**PARK CITY MUNICIPAL CORPORATION  
HISTORIC PRESERVATION BOARD  
CITY COUNCIL CHAMBERS  
December 5, 2017**

424 Woodside Avenue – HDDR Review for Reorientation - Reorientation (rotation) of a “Significant” Structure towards Woodside Avenue and lifting of the Historic Structure 7 feet 7 ¾ inches. The primary façade of the Significant Structure is currently oriented towards Main Street and the applicant is proposing to rotate the structure 180 degrees so that the primary façade is oriented towards Woodside Avenue. Upon reorientation, the Historic Structure would be lifted 7 feet 7 ¾ inches.

**Author:** Hannah M. Tyler, Planner  
**Subject:** Reorientation Review  
**Address:** 424 Woodside Avenue  
**Project Number:** PL-16-03379  
**Date:** December 5, 2017  
**Type of Item:** Administrative – Reorientation (Rotation)

**Figure 2b: Proposed Reorientation – West Façade**

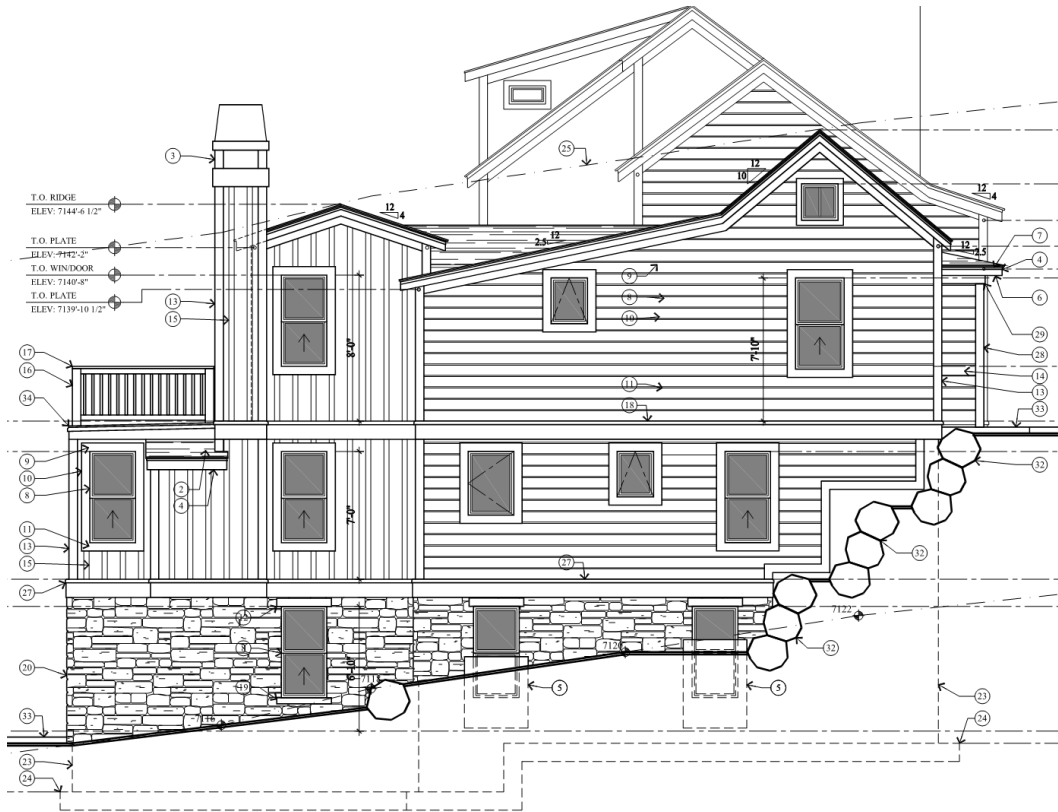
If the reorientation and proposed design is approved, the house will no longer read as a single-story structure and will appear larger and out-of-scale with its historic form. The proposed design, visible in Figure 2b articulates the scale and multi-level appearance of the proposed design once the Historic Structure is lifted and rotated.

**Figure 12:** Existing Conditions of the North Elevation – Approximate Measurement Of Main Floor Level Above Existing Grade.

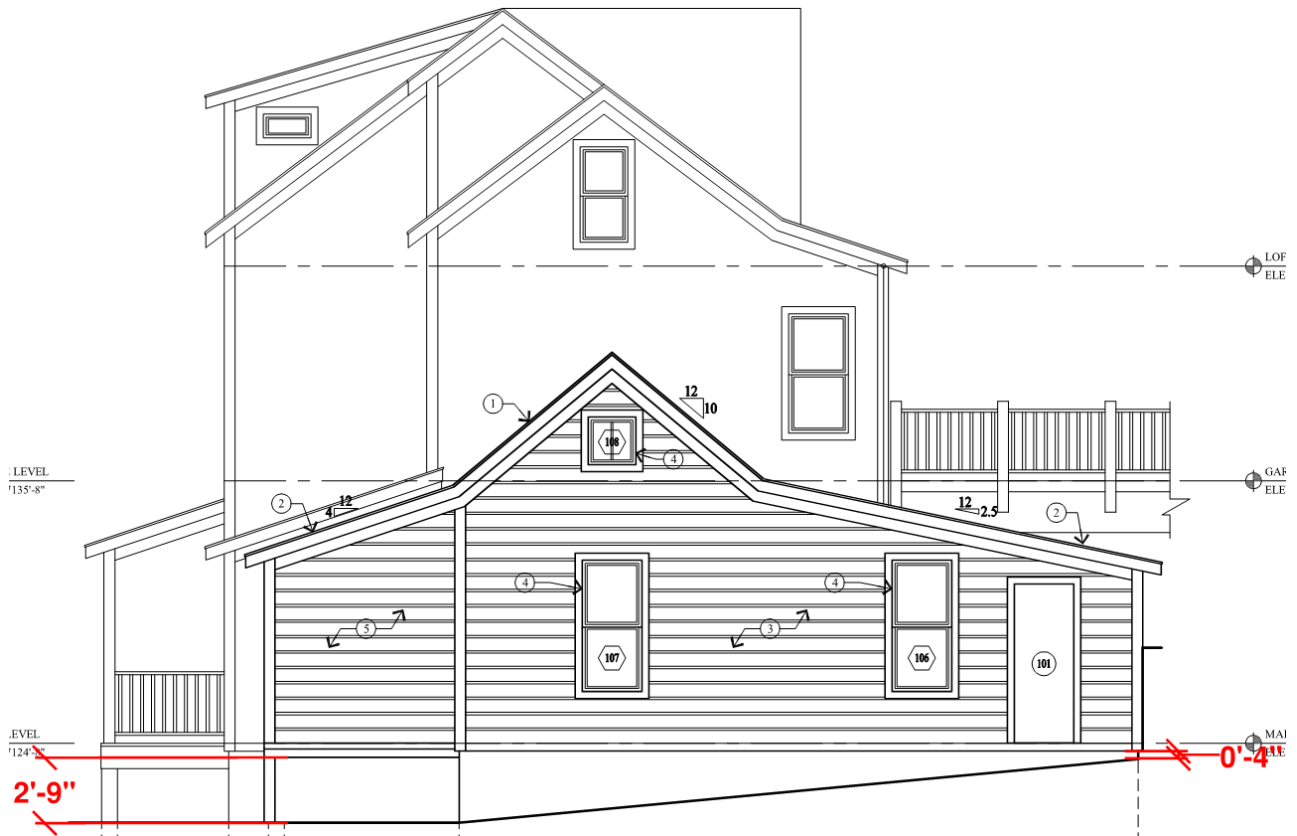
The Historic Structure's main floor level will go from being between approximately 4 inches and 2 feet 9 inches above existing grade to between approximately 1 foot and 13 feet 2 inches above Final Grade. Staff has identified this change in Figure 12 and 13.

Staff finds that the combination of reorientation and lifting (beyond what is specified in the Design Guidelines) results in the loss of Historic scale

**Figure 14a:** Existing Site Plan identifying the presumed remaining Historic Materials (in green). Drawing has been rotated, north is up and Woodside Avenue is to the left.

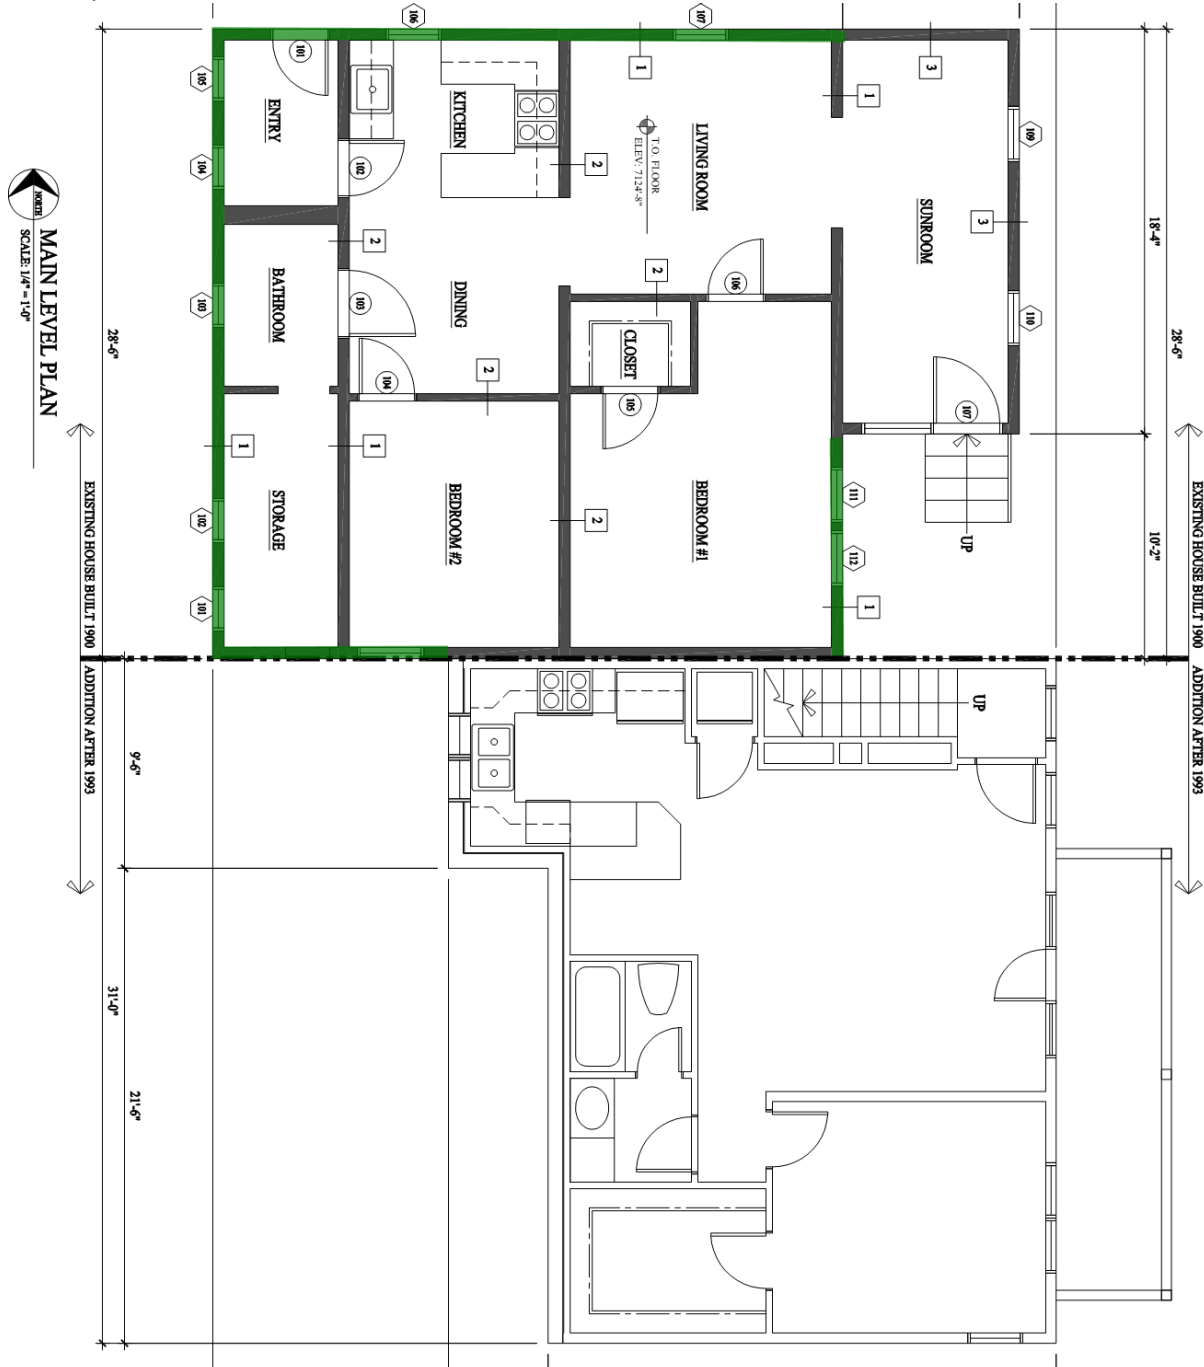
**If the Historic Structure is reoriented towards Woodside Avenue, the Historic Structure will lose its remaining historic material additions** (see Exhibits F and G for the applicant’s Historic Preservation Plan and Physical Conditions Report). Over the years, the Historic Structure has lost Historic material through remodel. Because of this, it is essential to retain what Historic material is remaining; otherwise this would be a Historic site with little to no Historic material remaining. While the LMC does allow for

reconstruction – meaning sites built with non-historic materials to match the historic materials – this proposal does not meet the criteria for Reconstruction. Staff has not determined unique conditions to warrant further loss of the remaining Historic materials and find that this aspect of Essential Historic Form will be lost if the Historic Structure is reoriented. Figure 14a and 14b articulates the approximate existing Historic material of the existing Historic Structure and the impact on Historic material after reorientation.

**Figure 14b:** Reoriented the Historic Structure – Presumed Historic Materials Lost (in red). The presumed Historic Materials remaining (in green). Drawing has been rotated, north is up and Woodside Avenue is to the left.

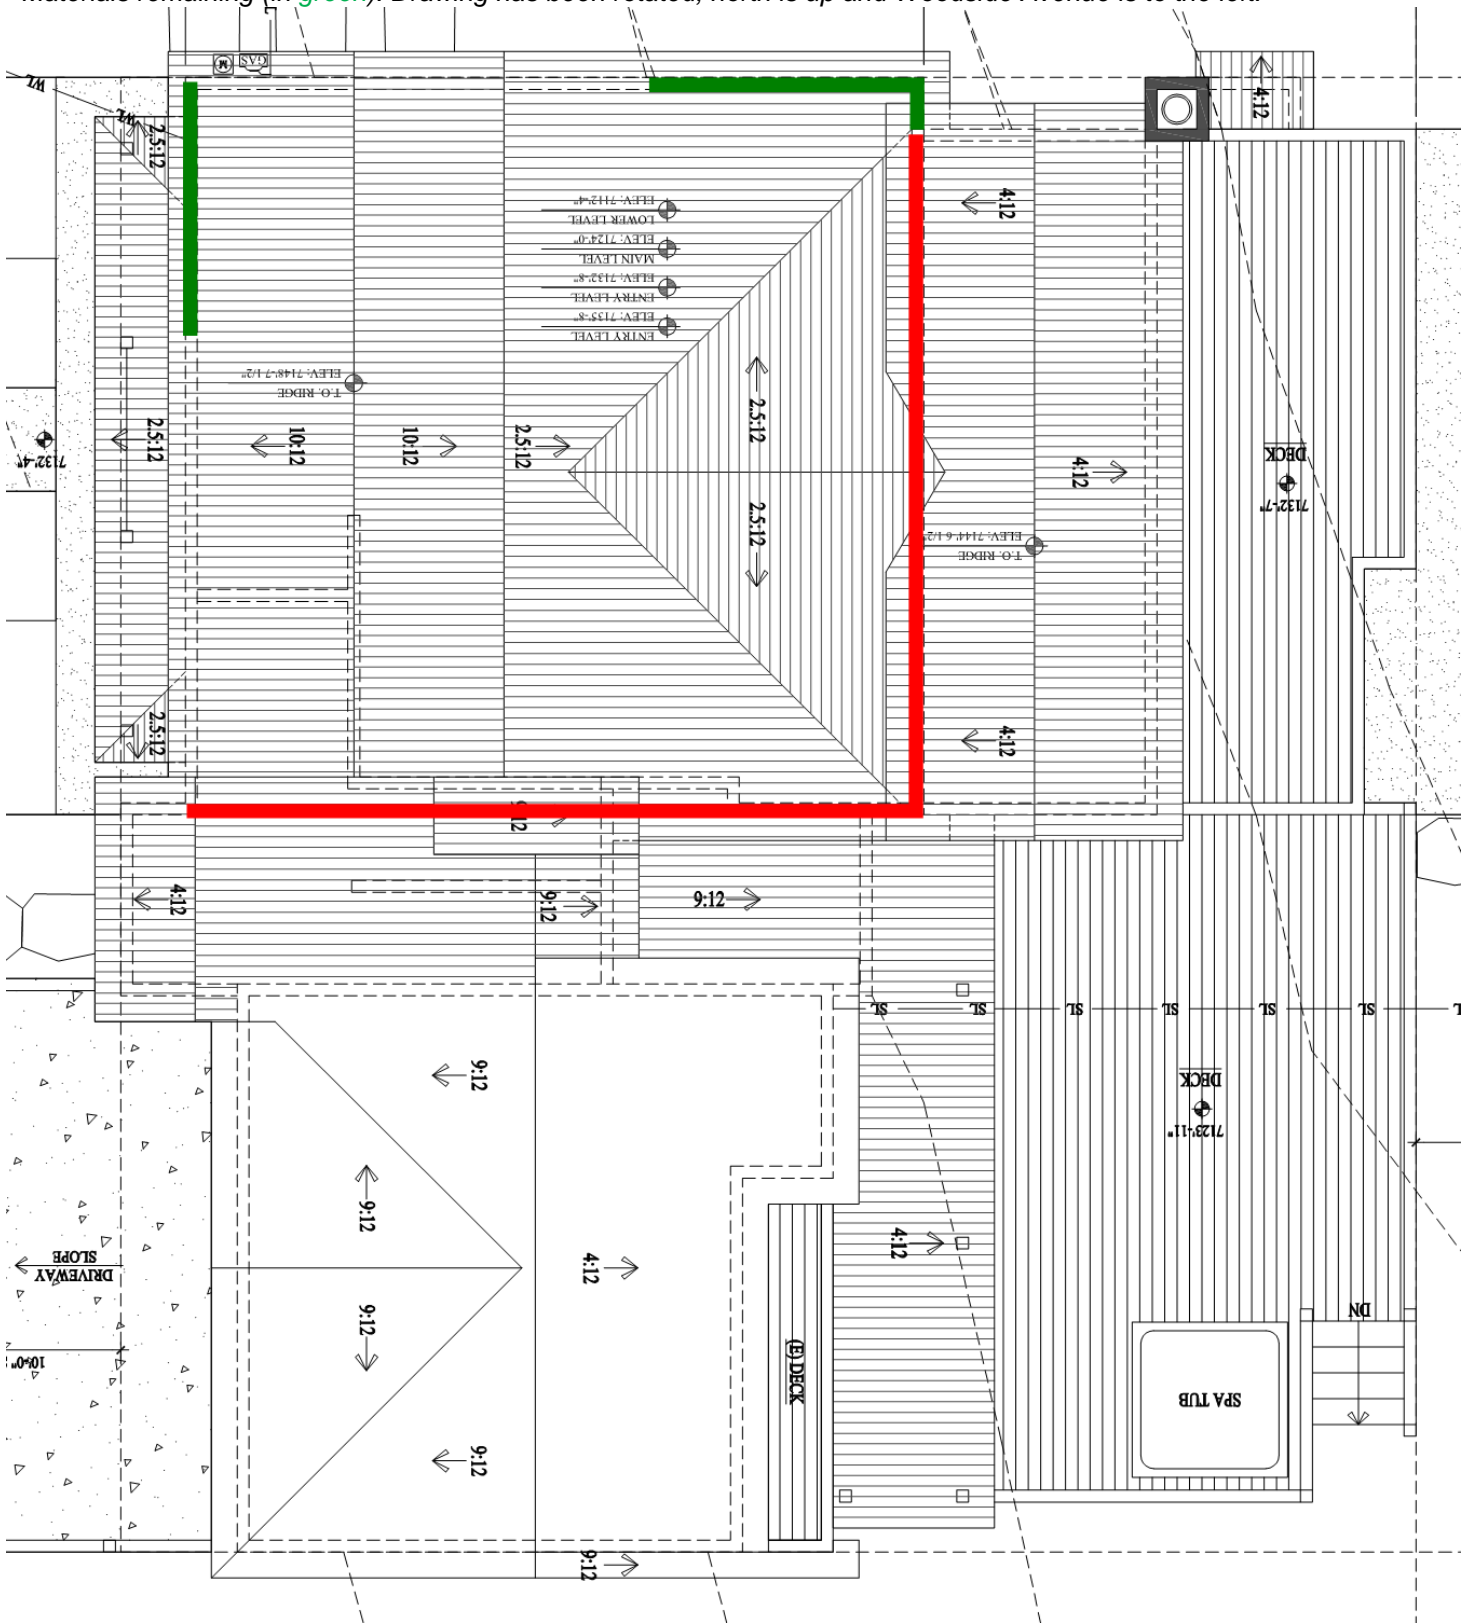
*In summary, if rotated, staff and the Design Review Team find that the Historic Structure will lose the three (3) aspects of Essential Historic Form that this site retains, including, Historic scale, context, and material.*
